1968 Corvette: Service Bulletin: Choke and Hot Restart Problems

Model and Year: 1968 Corvette with 427 cu. in. Engine

Bulletin No: 68-T-23 Re-Issue

Date: Apr. 24, 1968

FIGURE 1

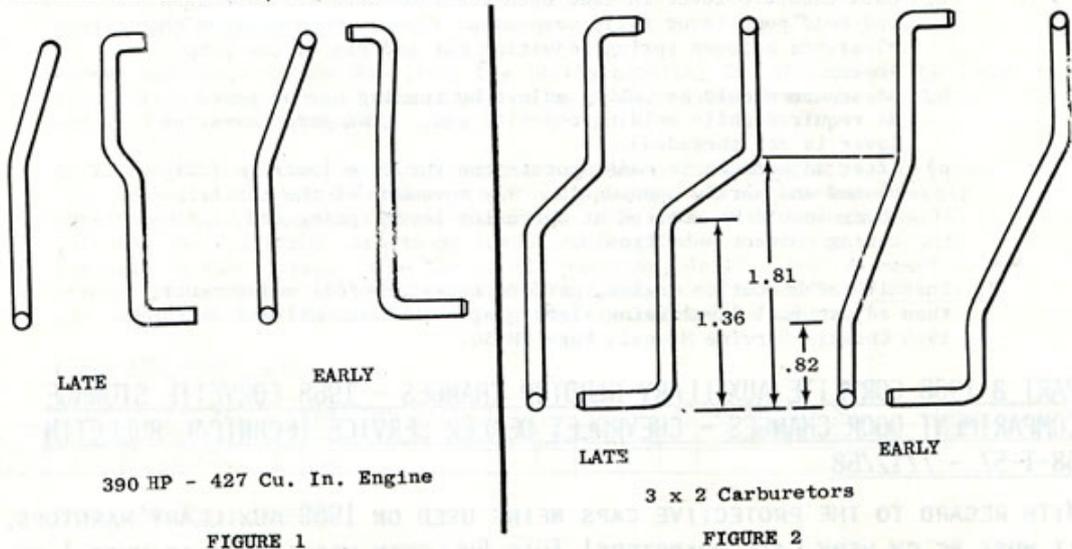
Install new choke rod (Part No. 3937738) which has a greater off-set and a reverse entry direction at the choke lever end. Adjust to one rod diameter interference by bending at the off-set as necessary.

FIGURE 3

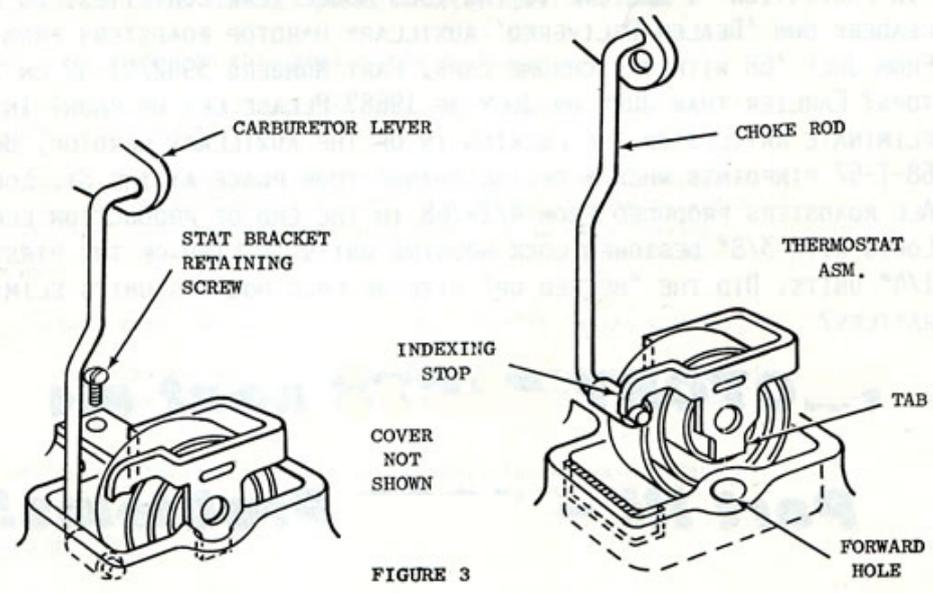
Install new choke rod (Part No. 3919899) which has a greater off-set leg length and check for interference between choke thermostat coil and the manifold pocket as shown in Figure 3. If interference exists in this area, adjust the coil as much as possible on its mounting location, and if necessary, grind the pocket area or the choke rod end to gain clearance needed.
